ADDENDUM NO. 1

TERRY CARGIL RESERVOIR

LACEY CONTRACT NO. PW 2019-32

X:\2019\02-TAC\1902-0076 To 1902-0100\1902-0076\1 - Project Data Files\5. CAD Drawings\100 Percent - Addendum 1\2021_12_23 EXTERNAL CET Reservoir Drawings - ADDENDUM 1 1902-0076.dwg S-8 12/23/2021 12:14 PM #####

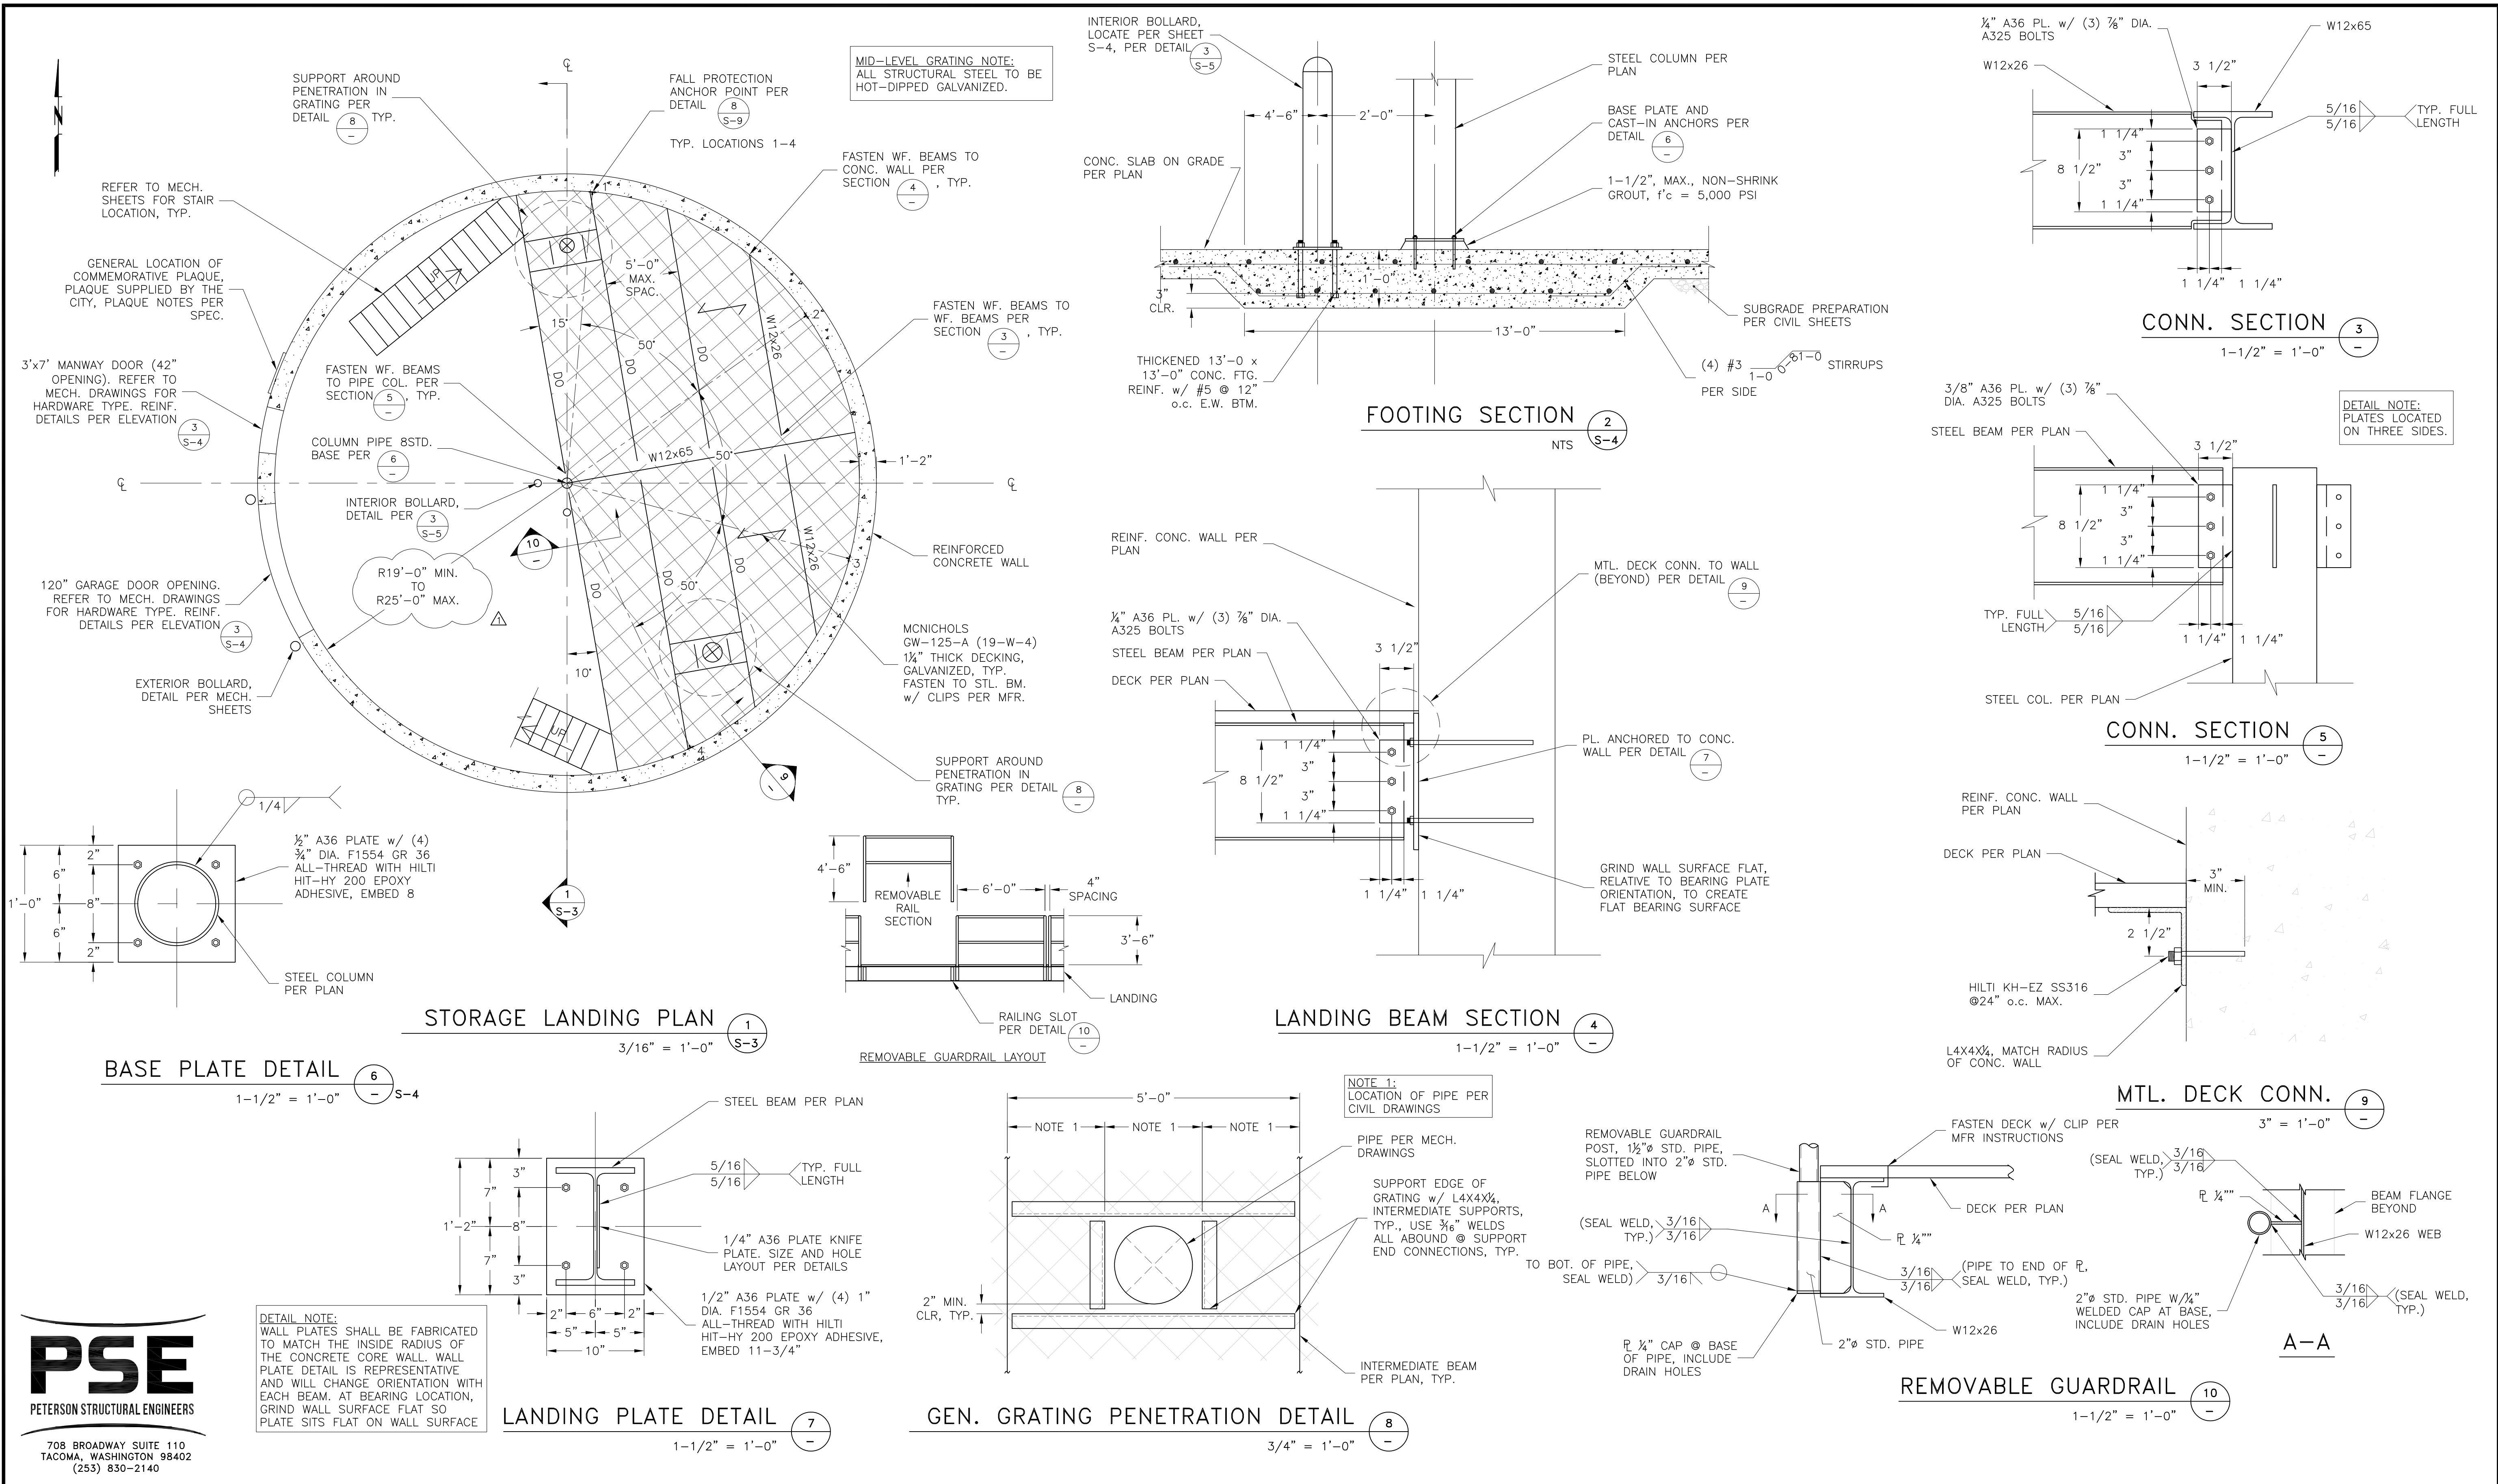
- 1) *The revisions include changes to notes related to the reservoir radius.*
Delete Sheet S-8 / Page 28 of 62 and replace it with the new page as attached.

M-1

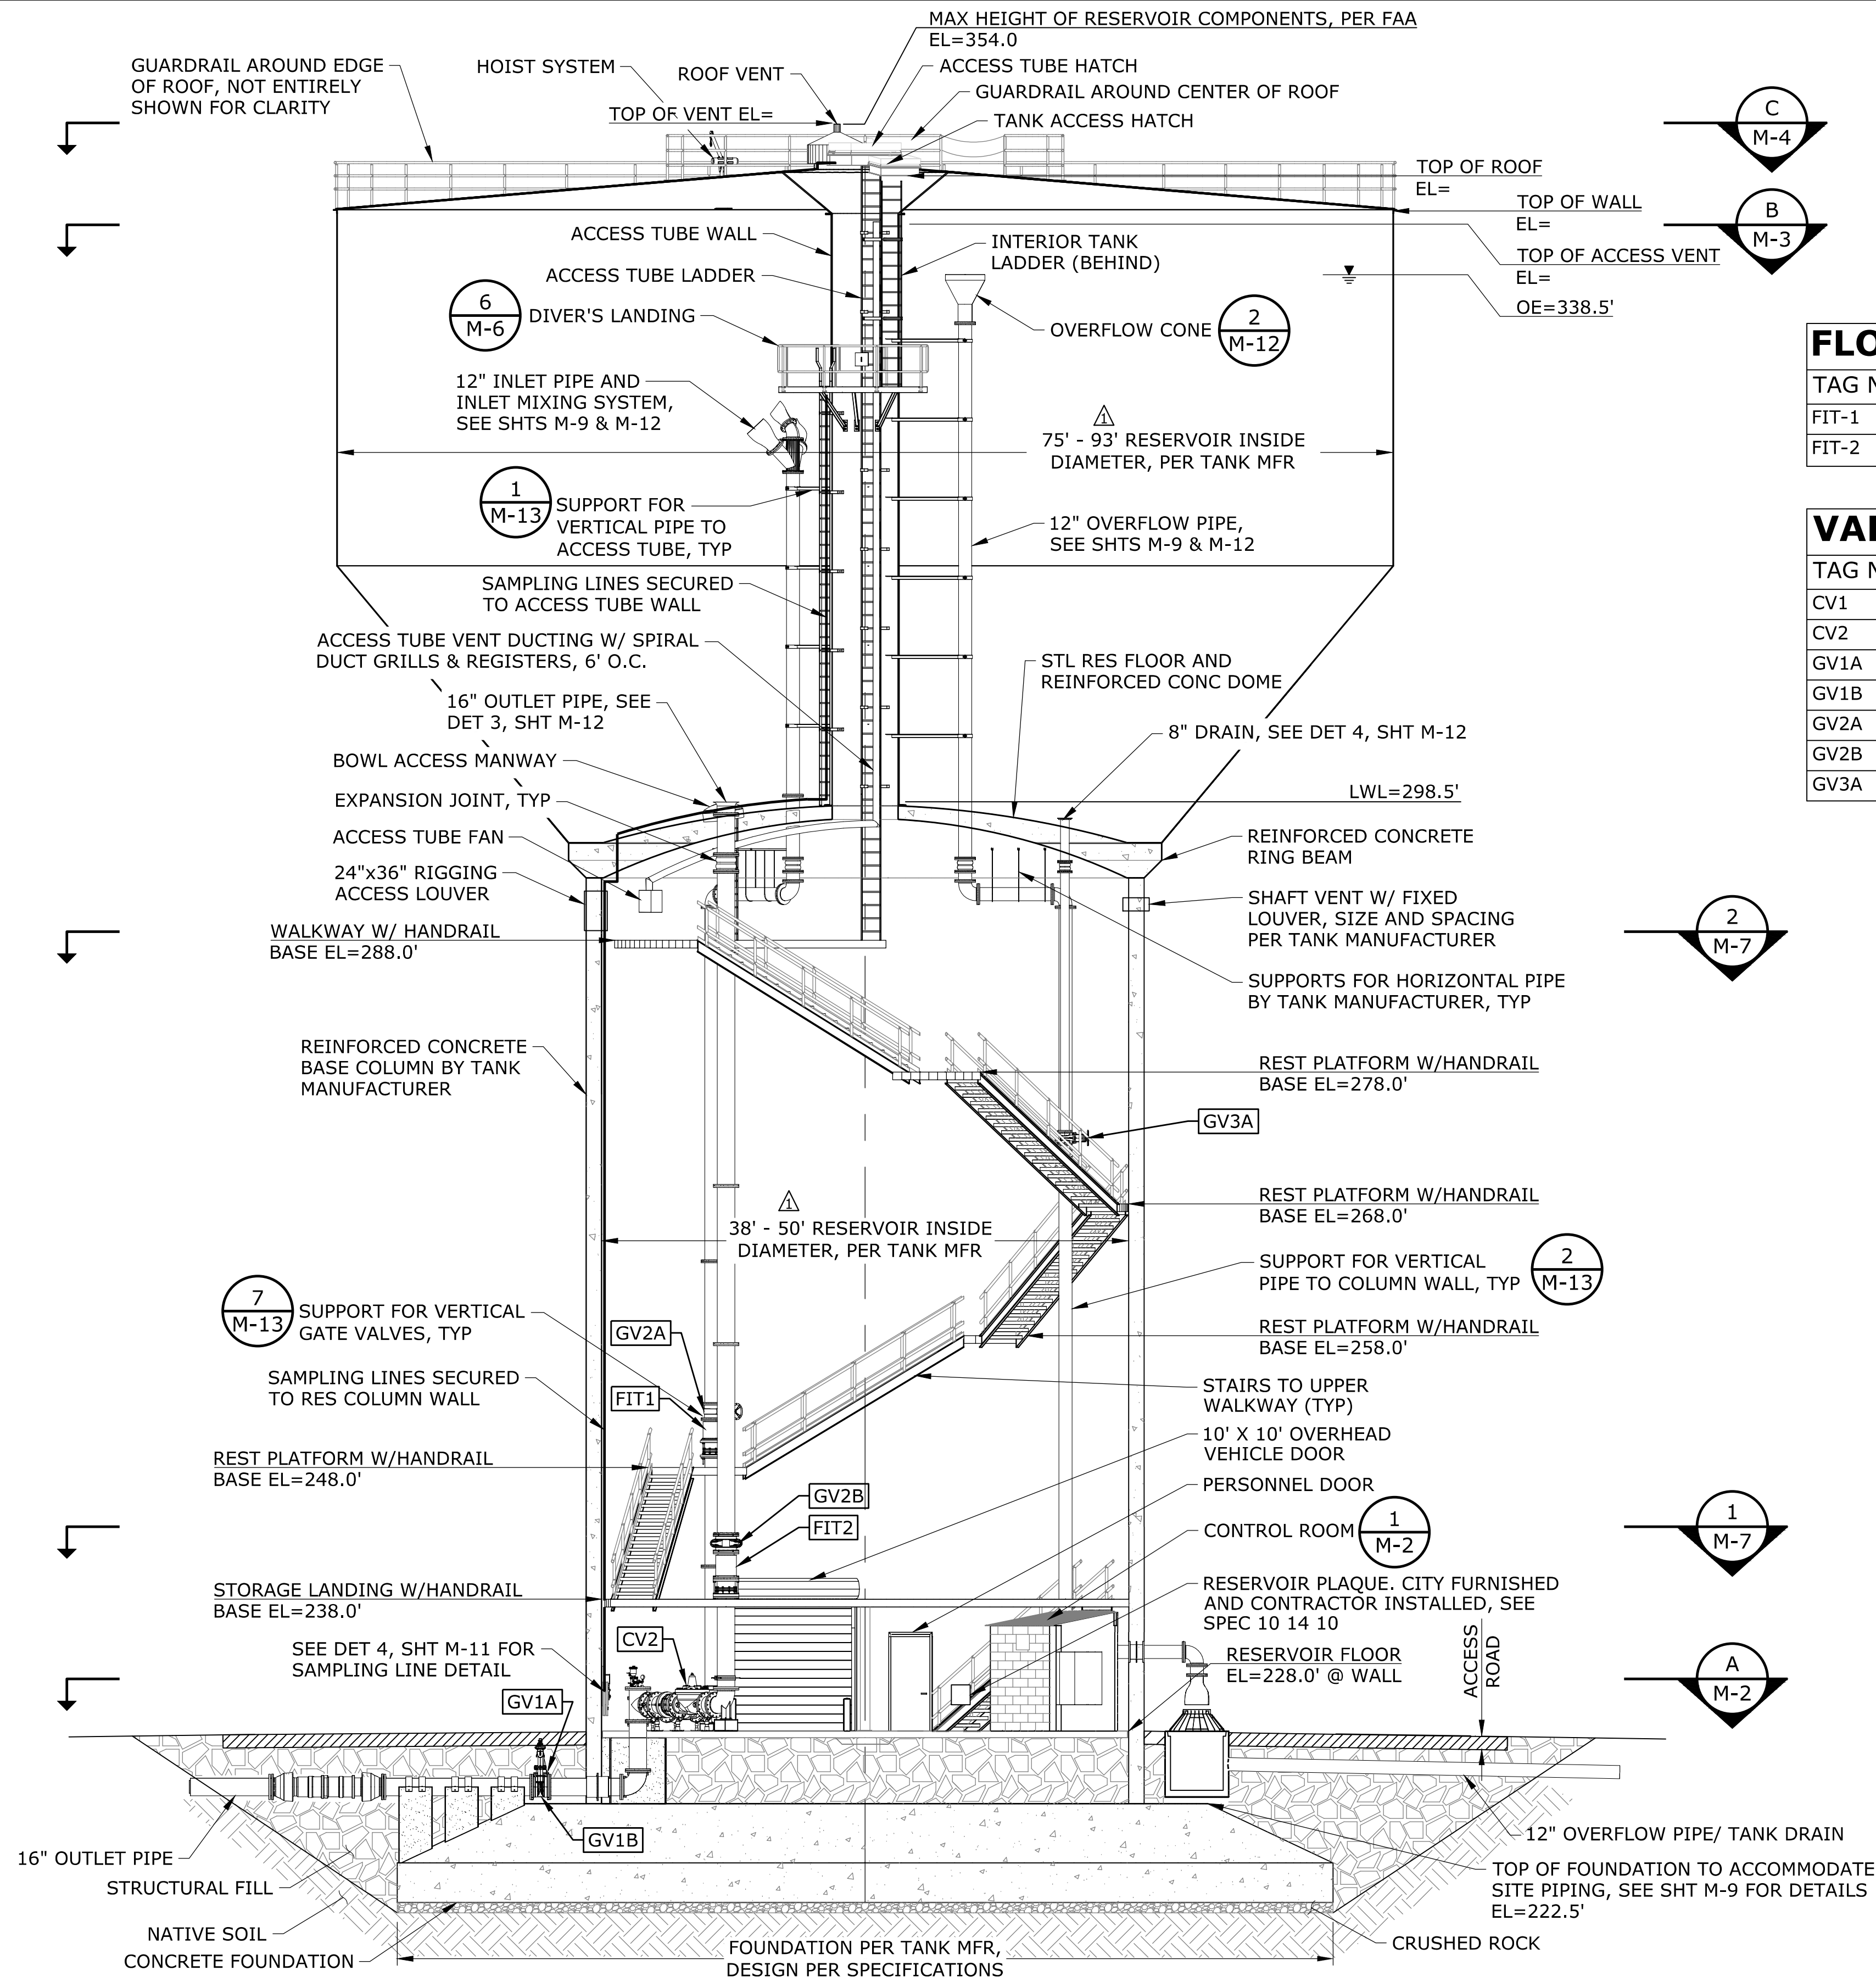
- 1) *The revisions include changes to notes related to the reservoir diameters.*
Delete Sheet M-1 / Page 32 of 62 and replace it with the new page as attached.
